Notice of Intent

Type of Action: Recompletion

Procedure Description: Hilcorp Energy Company requests to REVISE the NOI to adjust the perf ranges from the previously approved NOI on 1/25/2023 using the attached procedure, current and proposed wellbore diagram, the gas capture plan has not changed from the previous submission.

**HILCORP ENERGY COMPANY
GRENIER A 3M
FRUITLAND COAL RECOMPLETE SUNDRY
API 3004525833**

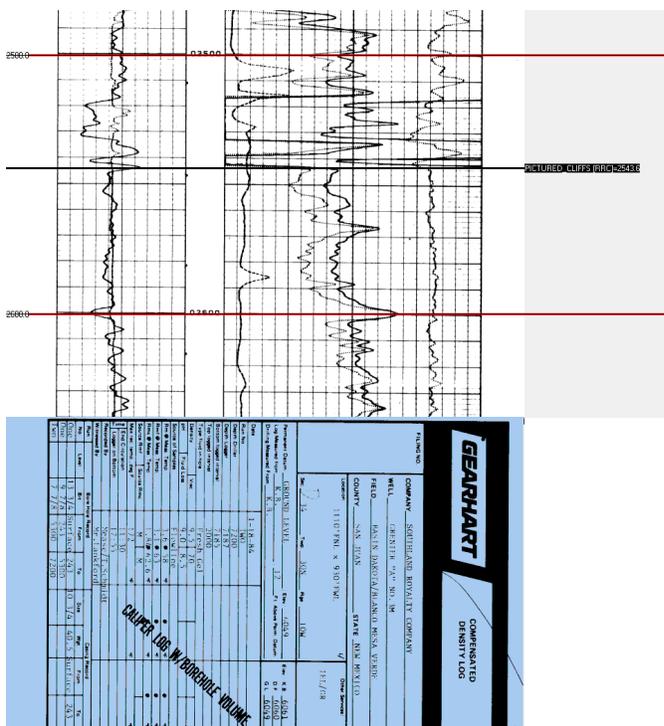
I see what you mean Russell; when comparing the gamma ray between the log with SP and Resistivity to the log with Density, there is a clear off set. As you already state if the issue is due to not considering the KB, then it would of course be the shallower depth which is correct, but I also agree that we do not know what actually occurred to cause this discrepancy.

Presumably Hilcorp has picked a new top for the PC, please provide additional information regarding what led to this new pick.

As such, we will be fine to proceed as you have proposed below.

I think I understand the source of confusion now. I must have picked my original top correctly off of the log you just referenced [which I agree should be 2530' MD], however when we went in to pick perms we typically use a density log if we have one, so that we can identify low density coal beds. It appears that the density log that we have for this well plots curves 14' deeper than the Induction Electric. I must've missed the discrepancy in log depths which is why we filed to lower the top. It could be that they didn't apply the KB correction to the deeper log, but we don't know that for certain. Having the deeper depth on the NOI would allow us to perf the correct interval should the deeper depth be correct. When we would go out to do the work we would run a strip gamma ray to insure we're perfring at the correct depths, and we could update the tops with an accurate depth at that time. I attached the two logs showing depth differences below as well as the log headers. They were run the same day by the same company in the same run it appears. I am not sure where the depth variation comes from. If you have any other questions please let me know and I'll be happy to take a look.
